Basic Impact Analysis (BIA)

Trans-Canada Highway Rock Slope Reprofilng 2015 Works

Addendum #1

Trans-Canada Highway: Sherbrooke Creek, Lower Sherbrooke
Creek, Little Topple and Phyllite Rock Slopes,
Yoho National Park, BC
May 2015

Figure 1 Aerial photograph of the proposed Mount Vaux debris storage area (outlined in yellow) and delineated boundary of the temporary to seasonally inundated marsh (outlined in white) detected during the field survey

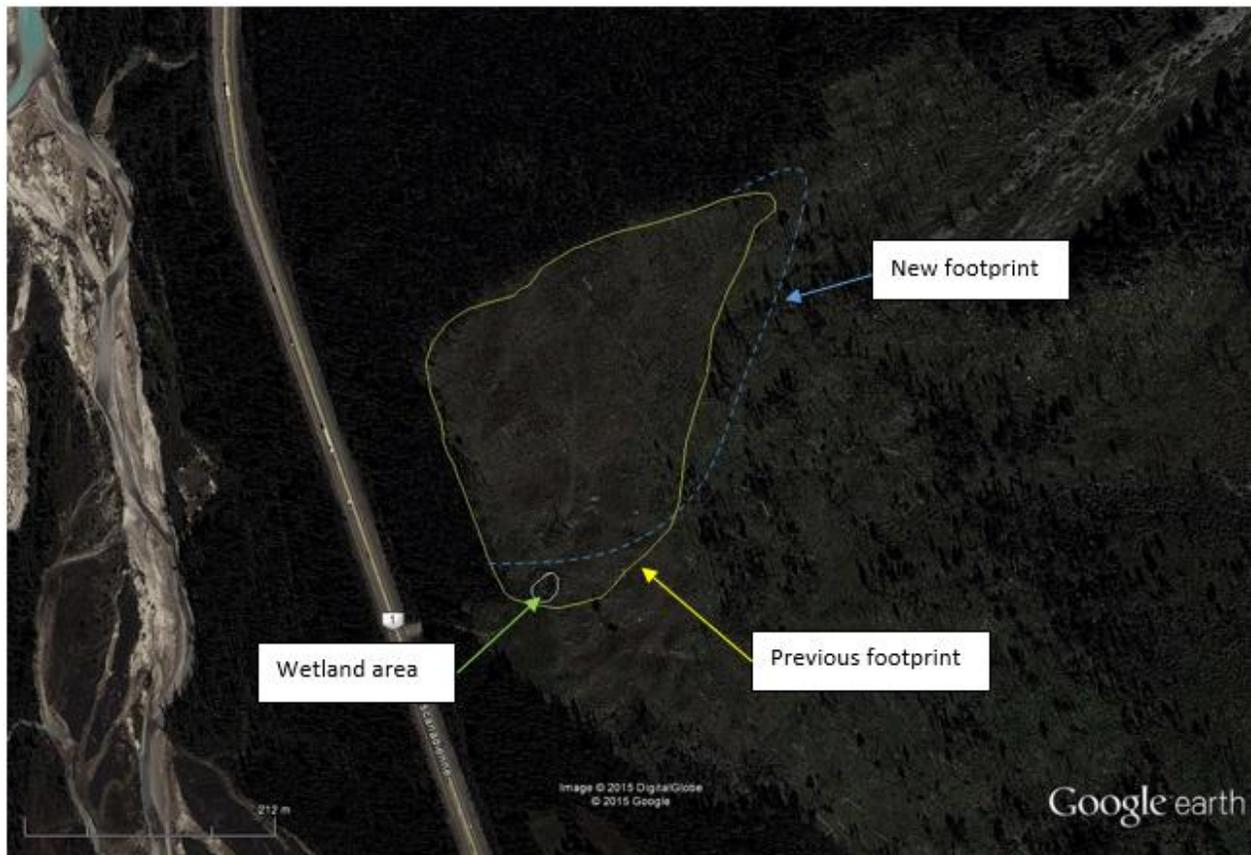
Tetra Tech EBA was requested by Parks Canada Agency (PCA) to conduct environmental studies for road improvements along the TCH in YNP, including investigation of a proposed (i.e.,) storage site at the foot of Mount Vaux near TCH kilometre (KM) 119+500 (measured westwards from the Banff National Park East Gate). The terrain at this site is very hummocky and is probably deposits from Mount Vaux placed after debris flood/ flow events. During field surveys conducted on June 6, 2015, an isolated marsh wetland (i.e., not surficially connected to other waterbodies), of temporary to seasonal inundation was observed within the southern limits of the proposed Mount Vaux debris storage area (Figure 1).

Tetra Tech EBA recommends that PCA maintain a 5 m vegetated buffer from the delineated margin of the wetland area, preventing infill and sedimentation of the wetland throughout the execution of associated debris storage activities. In the event that extensive erosion from stored debris piles is anticipated, silt fencing should be installed to provide protection from sedimentation of the wetland.

To the greatest extent feasible, natural drainage patterns should be maintained throughout the Mount Vaux debris storage area, preventing alteration of localized hydrology outside of the development area.

The storage site footprint shall be altered to avoid material being stored within 5 m of the observed boundary. Boulders shall be placed outside the 5 m buffer zone to avoid accidental encroachment.
